VN222468 – Proposed Residential Development, Primrose Lane, Liversedge

Transport Assessment Addendum Note

DRAWING NUMBER: **VN222468-D100** REVISION: **E**

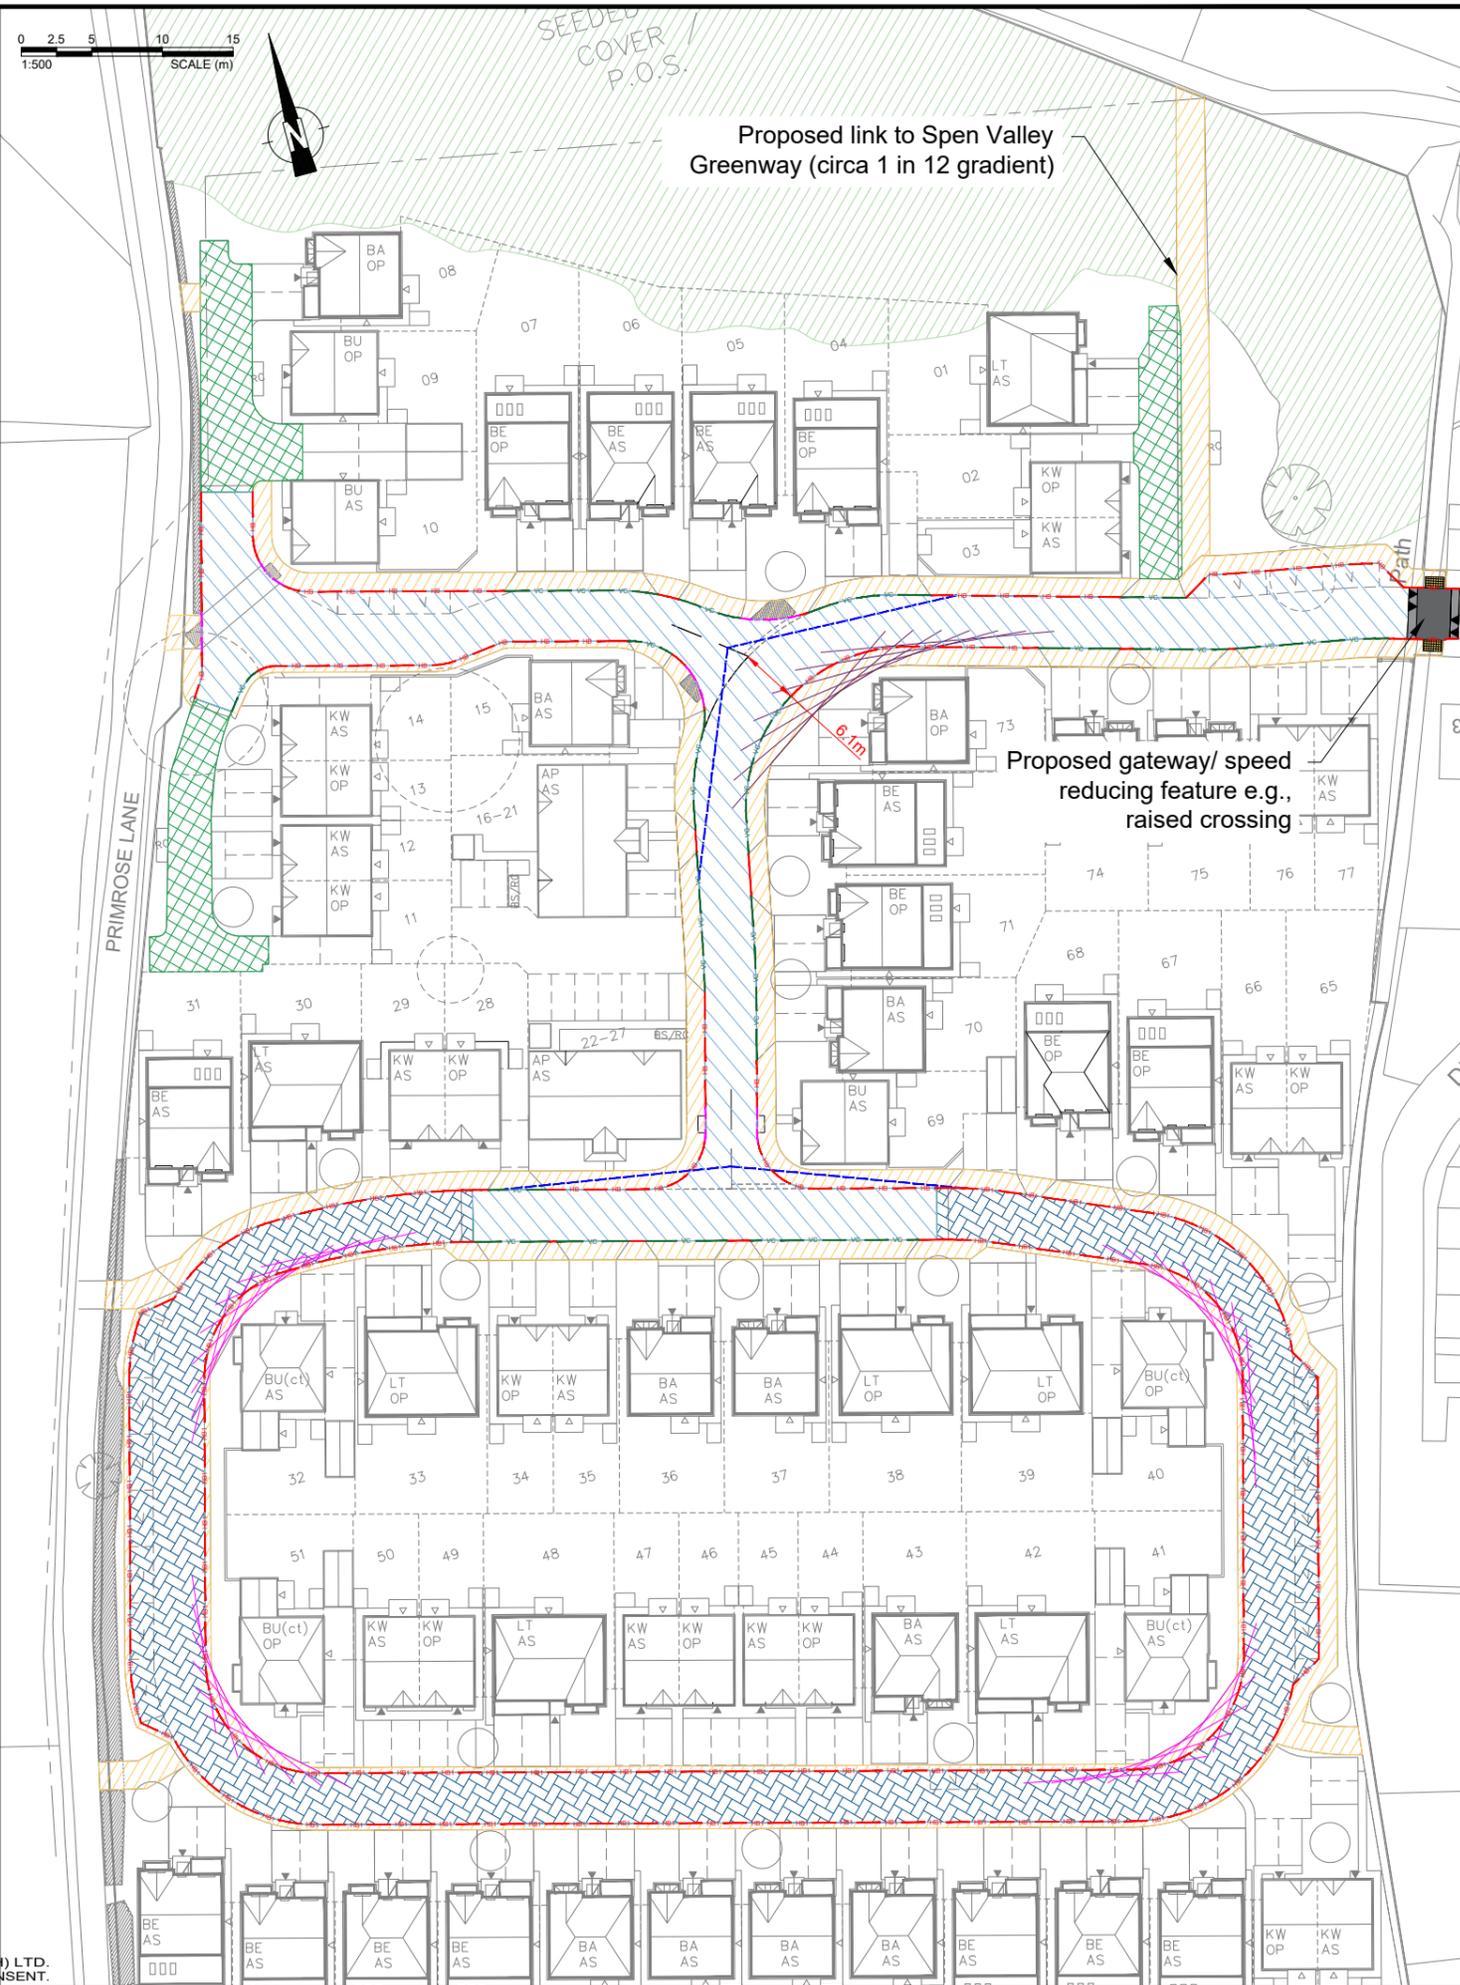
The drag distance from Plot 9 to the BCP is approximately 35m, which is in excess of the distance specified in guidance (max 25m). The drag distance from the Bin store to the BCP on the adopted highway is approximately 19m that is in excess 8m (for 240ltr bins). Reversing RCV's is a recognised safety hazard and WISH guidance specifies a maximum reverse distance of 12m. Without provision of a turning head the reverse distance from the loop road to Plot 7 is approximately 35m that is not acceptable.

Adequate junction and forward visibility splays appear to have been demonstrated. However, these splays must be contained within the adopted highway, which will require some amendment to the hard margin/footway widths to accommodate this. These amendments should be made, and the proposed highway boundary and visibility splays clearly marked on this plan.

The proposed layout of this part of the site has been updated to ensure that the bin drag distances are appropriate in line with the relevant KC guidance document entitled 'Emergency Access, Waste Management, Servicing and Deliveries' (2020 version 1), including the provision of a turning head. The preliminary highway layout and vehicle tracking is shown on **Drawing VN222468-D100 Rev E**.

Appropriate amendments have been made to the hard margin / footway widths to accommodate the visibility splays within the adopted highway, as shown on **Drawing VN222468-D100 Rev E**.

Dimensioned plans with visibility splays and forward visibility sightlines are shown on **Drawing VN222468-D100 Rev E**.

Indicative details of proposed kerbing and surface treatments, and the extent of proposed highway adoption and unadopted communal areas are shown on **Drawing VN222468-D100 Rev E**.

DRAWING NUMBER: VN222468-TR100 REVISION: E

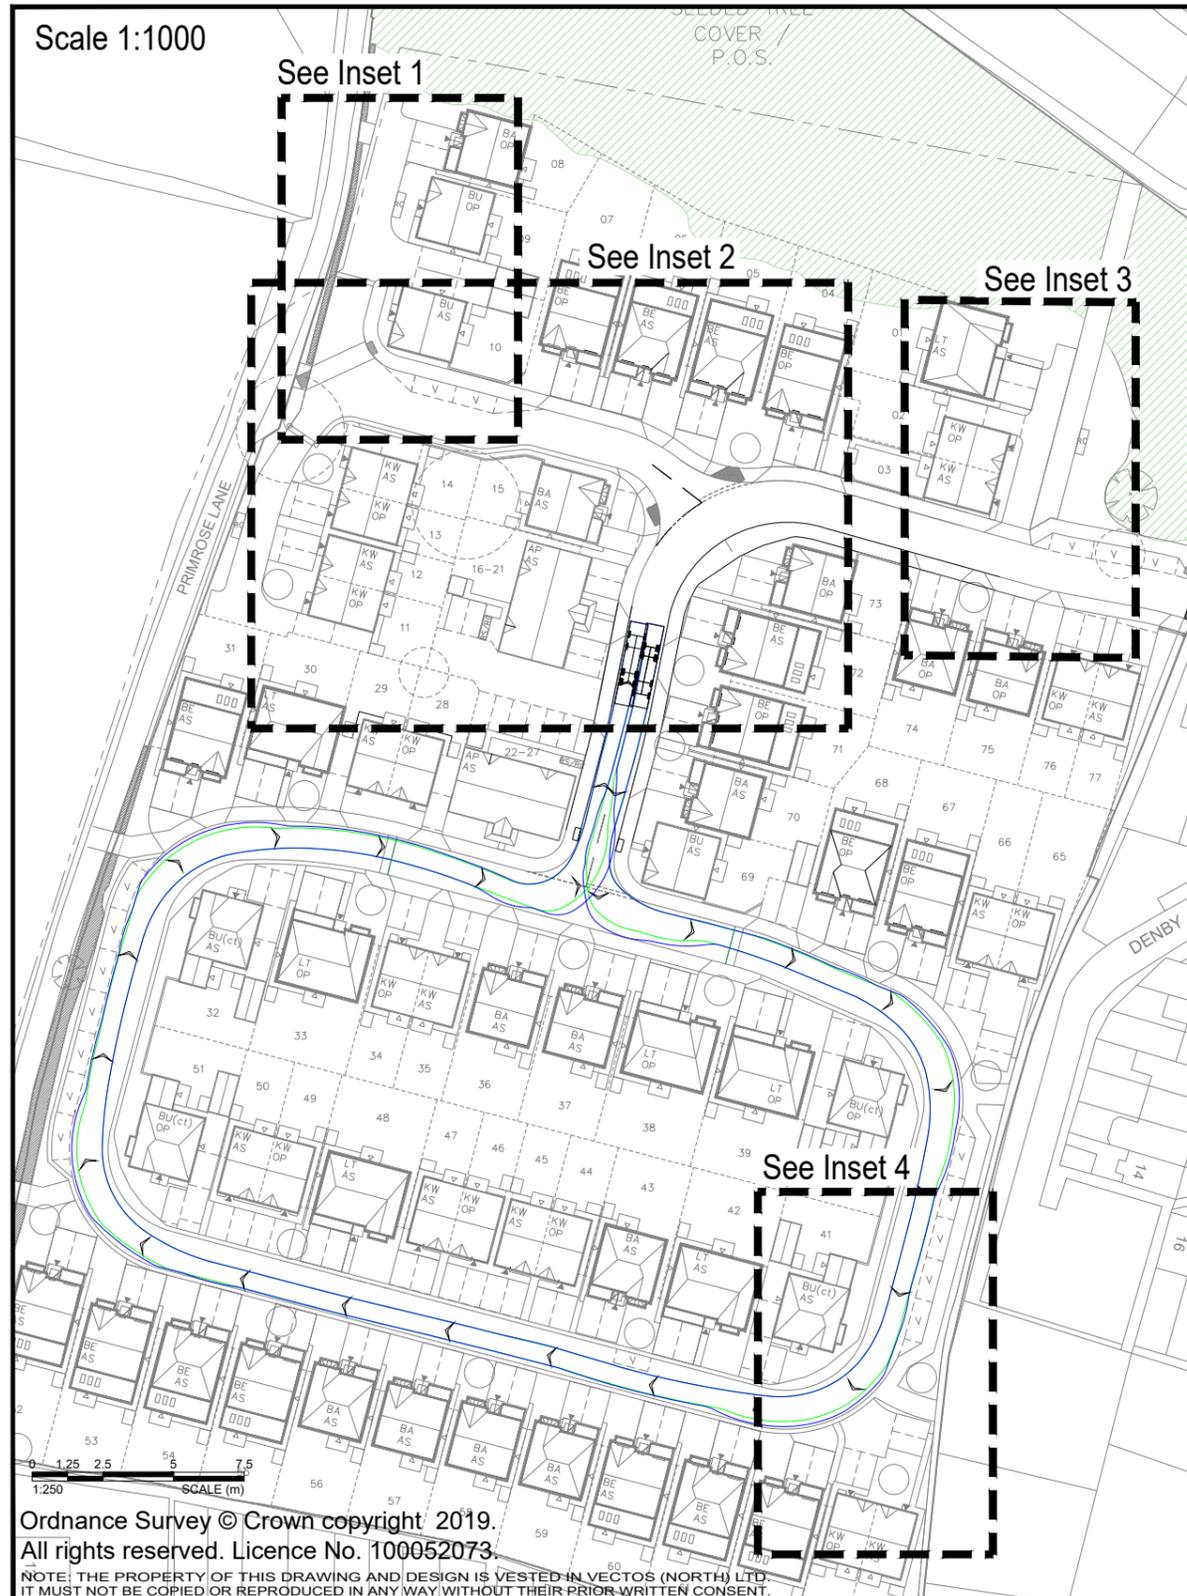
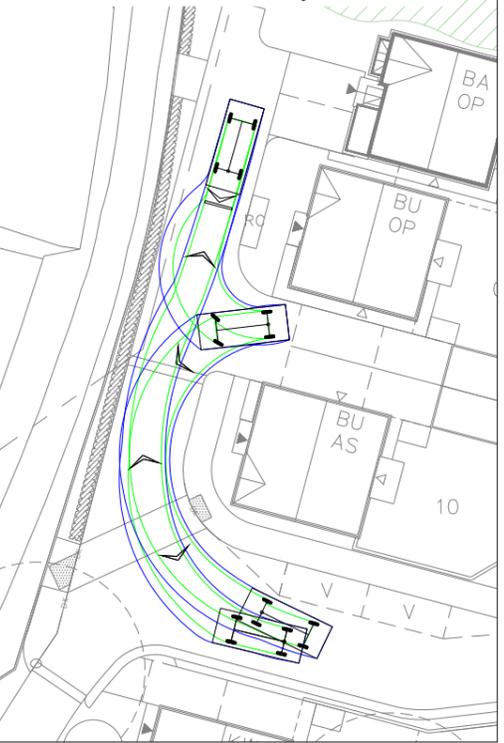
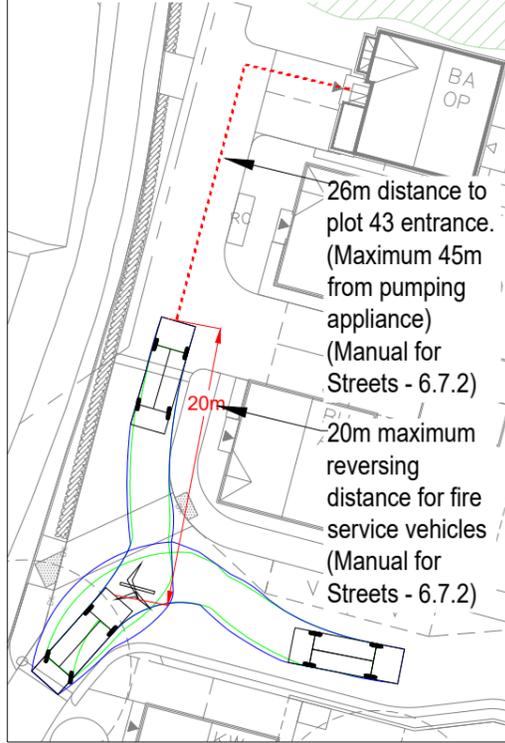
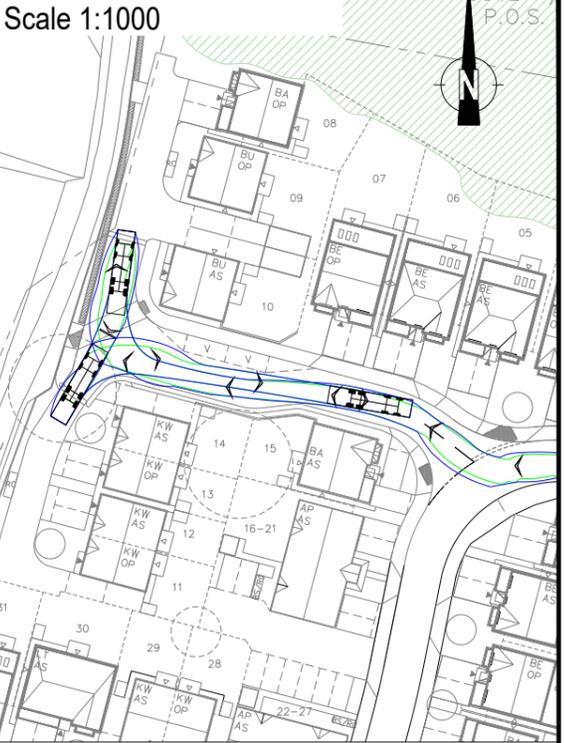
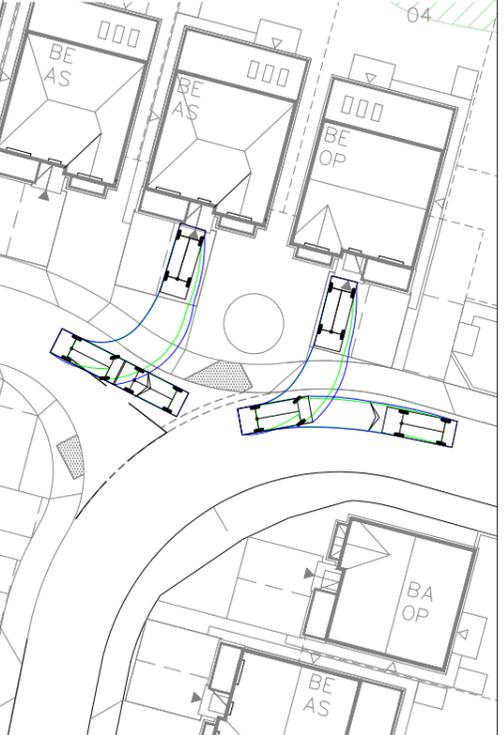
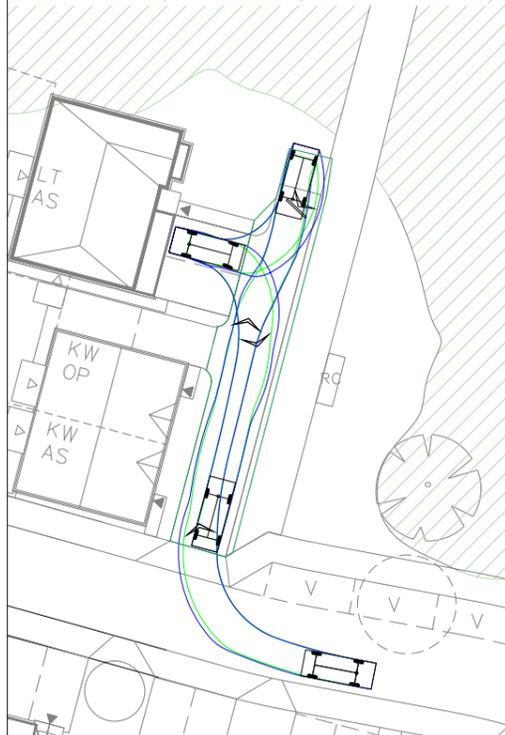
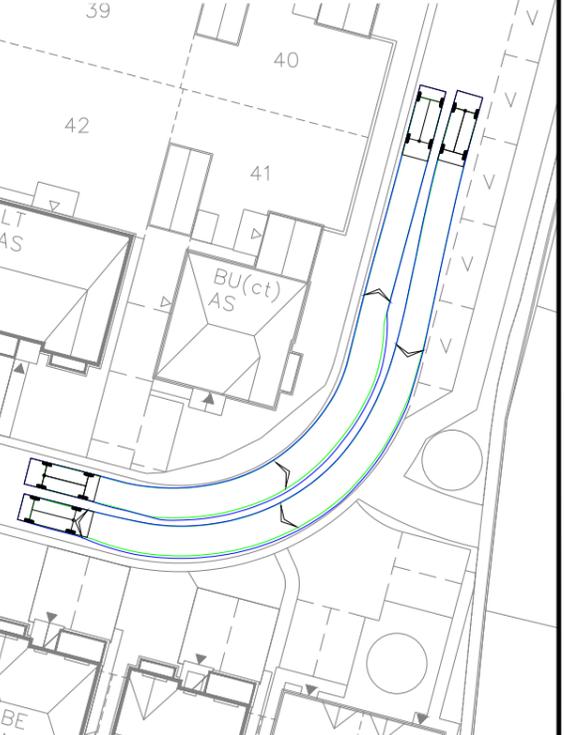
In addition to the above comments from Waste Strategy, it is noted that the cul-de-sac serving Plots 4-9 is in excess of 20m in length. Therefore, in accordance with West Yorkshire Fire and Rescue advice (and the Councils Highway Design SPD), a turning head must be provided. It is also noted that the maximum hose distance of 45m is exceeded for Plots 8-9.

The swept path analysis demonstrates that a refuse vehicle cannot pass a car at the bend adjacent to Plot 63. This bend should be widened to a minimum of 6.1m, and have a centreline radius of at least 20m, to ensure that vehicles can safely pass and obstructions to the refuse vehicle do not occur.

An appropriately designed turning head is now provided on this cul-de-sac, and the proposed access arrangements for a fire tender ensure a maximum hose distance of 45m is not exceeded for Plots 8-9, as shown on **Drawing VN222468-TR100 Rev E**.

The shared surface loop section of carriageway in the southern part of the proposed development site adjacent to plot 63 is not designed to accommodate the passing of a car and refuse vehicle, and this is considered appropriate given that this part of the residential site is proposing a 15mph design speed and it will be very lightly trafficked. The proposed design of the carriageway at this bend facilitates the passing of two cars, as shown on **Drawing VN222468-TR100 Rev E**.

Updated swept path analysis of the revised site layout is shown on **Drawing VN222468-TR100 Rev E**.
